Proposal for a new series of amendments to UN Regulation No. 116 (Anti-theft and alarm systems)

Submitted by the expert from the International Organization of Motor Vehicle Manufacturers

The text reproduced below was prepared by the expert from the International Organization of Motor Vehicle Manufacturers (OICA) to amend the definition of keys taking into account innovative vehicle alarms systems. It is based on the official document GRSG/2019/7, presented at the 116th session of the Working Party on General Safety Provisions (GRSG) (see report ECE/TRANS/WP.29/GRSG/95, para. 48) and on informal document GRSG-115-20, presented at the 115th session of the Working Party on General Safety Provisions (GRSG) (see report ECE/TRANS/WP.29/GRSG/94, para. 49). The modifications to the current text of UN Regulation No. 116 are marked in bold characters for new text, and strikethrough for deleted text.

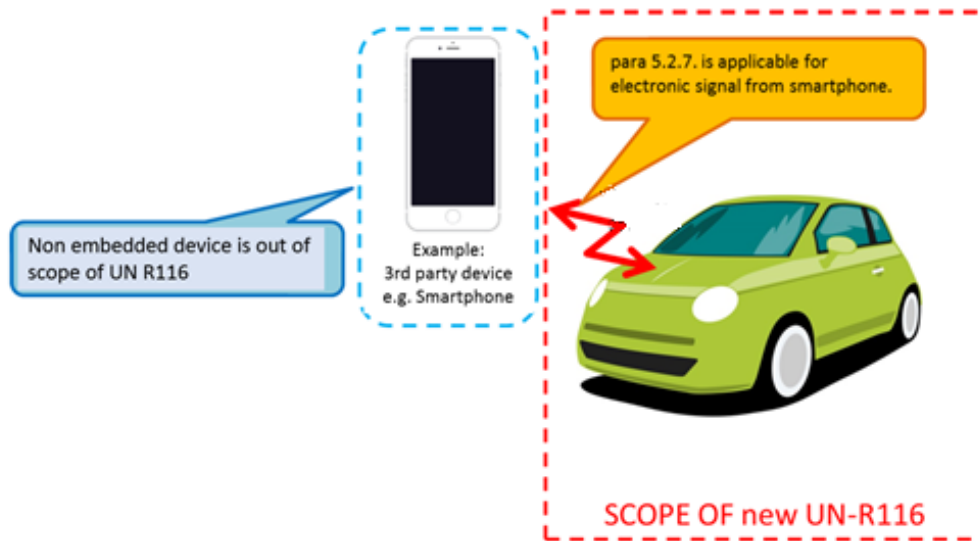
3. To access the vehicle, not only physical keys can be used but also purely electrical ones.
4. According to the current definition of "key", a smartphone cannot be covered as "only by that device". This is the reason why "electronic solution" is added to definition. The hardware (e.g. smartphone) and software transmitting the electronic solution to the vehicle are not in the scope of UN Regulation No. 116. If the electronic solution is defined as a key, it is reasonable that the electronic solution transmitted from the hardware fulfils

the requirements of paragraph 5.2.7. (Electrical/electronic locking systems - See figure below).
